UNITED STATES PATENT AND TRADEMARK OFFICE

APPLICATION NO.	FILING DATE	FIRST NAMED INVENTOR	ATTORNEY DOCKET NO.	CONFIRMATION NO.
09/927,251	08/10/2001	Alex Waluszko	001-17	4302

Office Action Summary

DETAILED ACTION***Drawings***

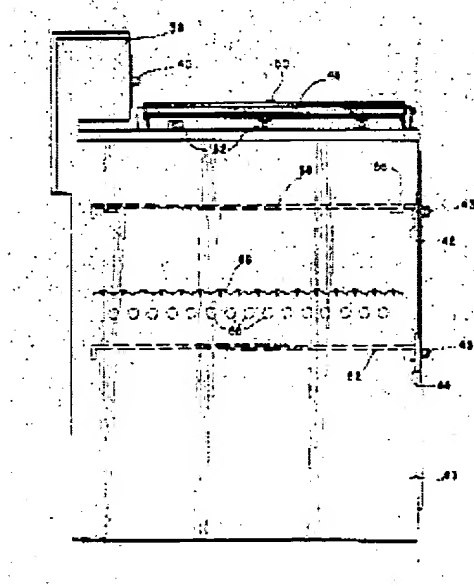
2. Claims 1-11 are rejected under 35 U.S.C. 102(b) as being anticipated by Gush et al. (US 3619601).

Gush et al. disclose an apparatus for irradiating an article comprising:

(a) a housing (FIG. 5);

(b) a support disposed within said housing for supporting the article (FIG. 5, element 58);

(c) a source of radiation disposed within said housing at a spaced apart location from said support (FIG. 5, element 66 and column 11, line 32-37);

(d) shutter means (FIG. 5, element 68) disposed intermediate said support and

FIG. 8

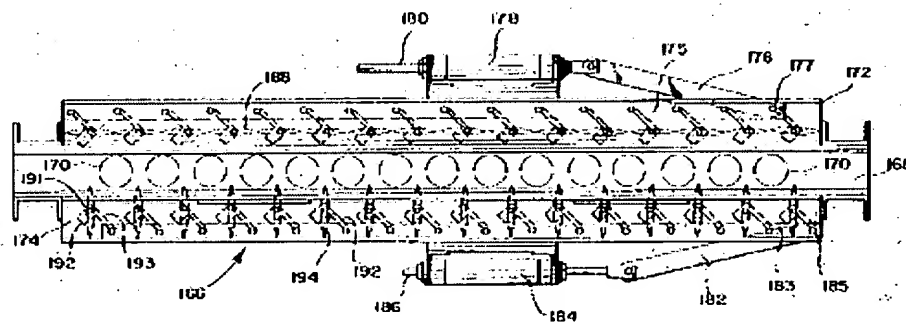
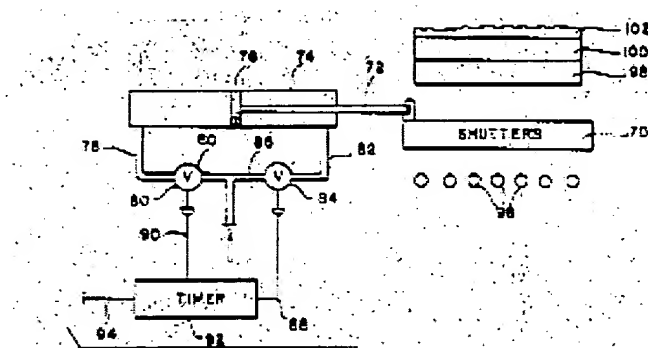
(a) a supporting frame mounted within said housing proximate said planar array (FIG. 8, elements 172, 174, 175); and

(b) a plurality of blocking elements (Fig. 8, element 188) connected to said supporting frame for movement between a first, shutter closed position to a second, shutter open position (FIG. 8).

Referring to claim 11: said blocking elements comprise a plurality of vanes pivotally connected to the said supporting frame for movement between a first shutter open position and a said second shutter closed position (FIG. 8, elements 188 and 194).
